**Crysteel® Manufacturing
I-Beam Technical Bulletin
Updated March 18, 2013**

I-BEAM LONGBEAM SPACING FOR CRYSTEEL CROSSMEMBERLESS FRAMES

Change overview

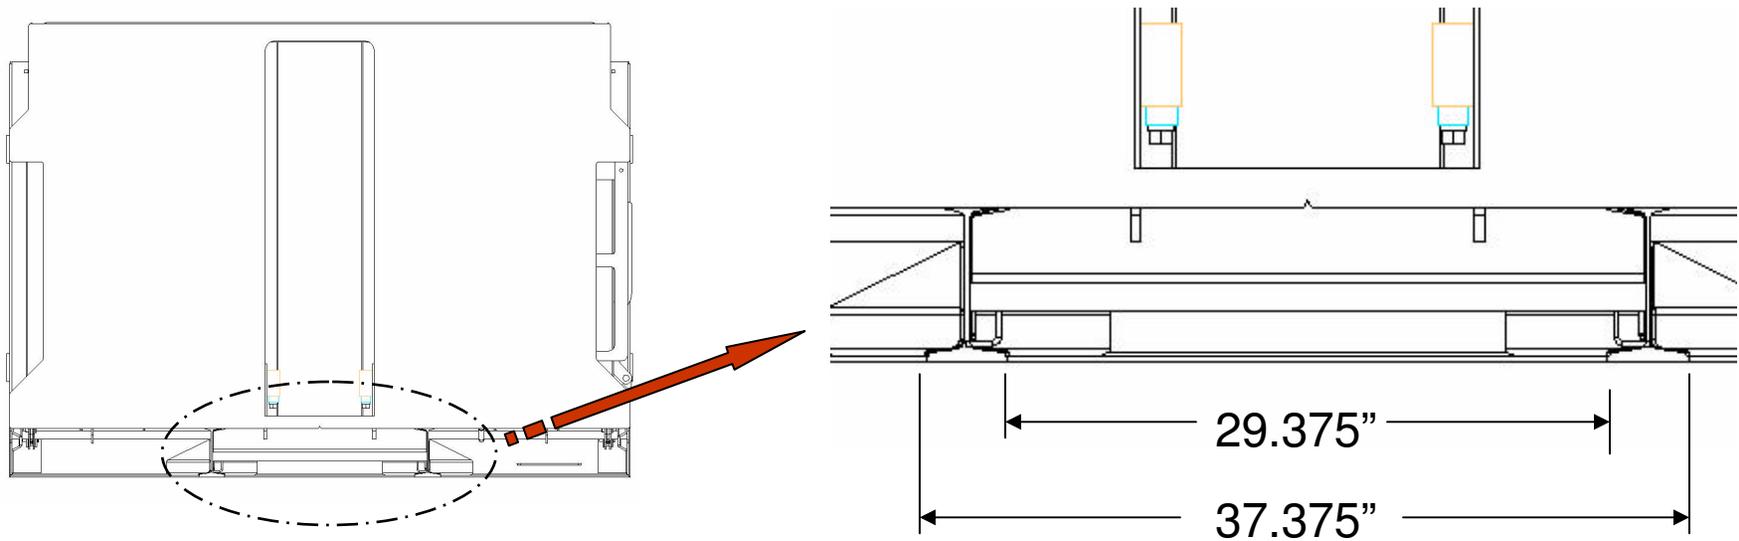
The following document reviews a change that was made to the standard I-beam longitudinal spacing for Crysteel and J-Craft dump bodies in February of 2012.

- Crysteel uses 8" and 10" I-beams for our longbeams which are now spaced at 29.375" between the INNER FLANGE. Formerly they were spaced 29.375" between the WEB.
- This will put the outer flange outboard of the chassis rail by 1-1/2" – 2" per side.
- This design was originally used, and accepted by J-Craft customers for years and used by municipalities and general contractor applications.

Chassis installation....

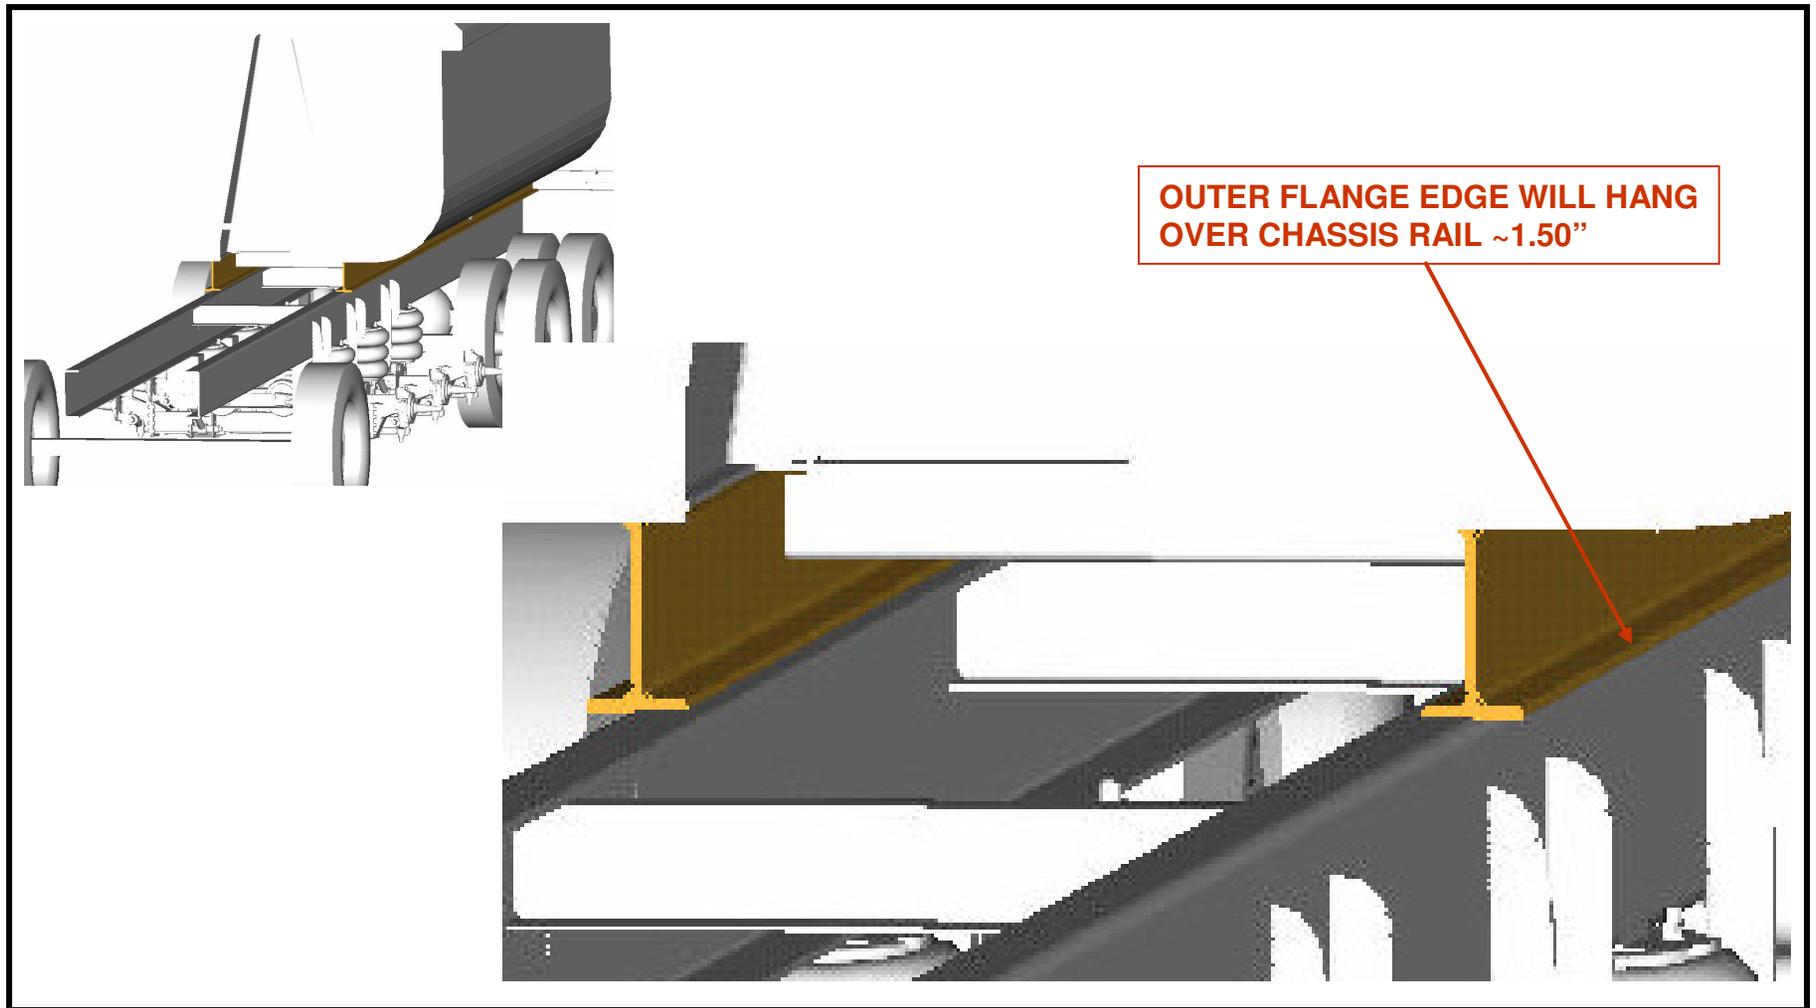
- The spacing of 29.375" between the inner flanges will put the outside of the WEB almost in-line with the chassis frame rail. This means the outside flange will hang outboard of the chassis rail by 1-1/2" to 2" depending on the size of the I-beam.

Pro's and Con's of current design

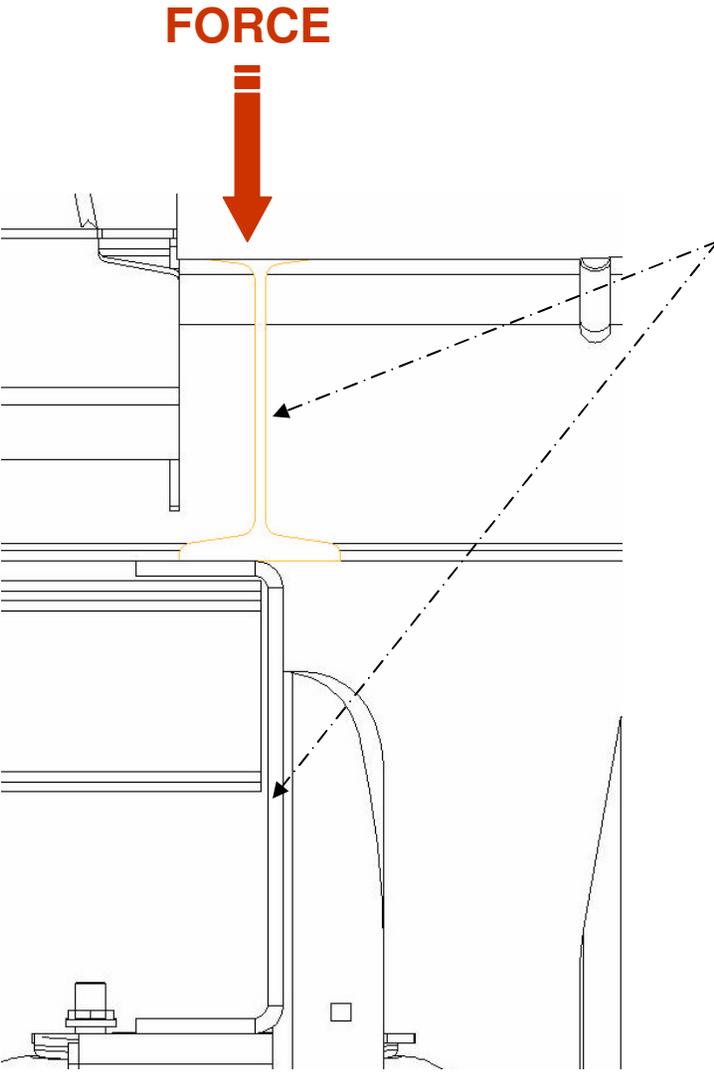
PRO'S
Stronger design because the structural members are in-line.

Conversely, when the web is inboard (*former spacing*) it increases the stress on the chassis rail because of the cantilevered effect it has on the upper leg of the chassis rail.

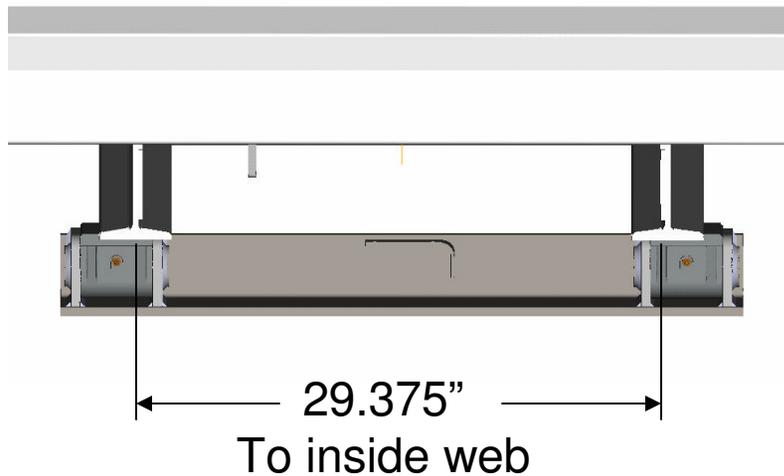
Distributors may need to modify mounting brackets of supplemental equipment if it is mounted above the top of the chassis rail.

Some type of spacer will need to be welded to the bottom of the I-beam by the distributor to fill the void between the I-beam and chassis rail.
(*Intermittent spacers are supplied by Crysteel in the hoist install kits*)

Hinge mounting comparison....

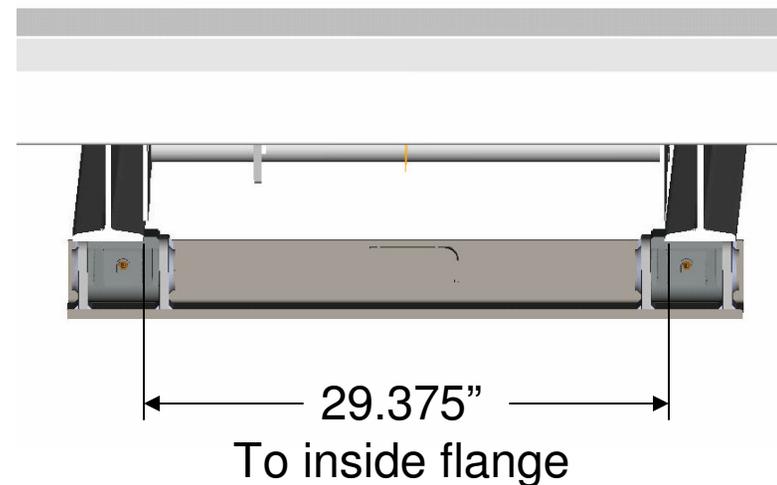
End view of how beam lands on hinge pad.

Former Spacing

Current Spacing

Note: There are specially designed Rear Hinges designed for I-beam longitudinals.
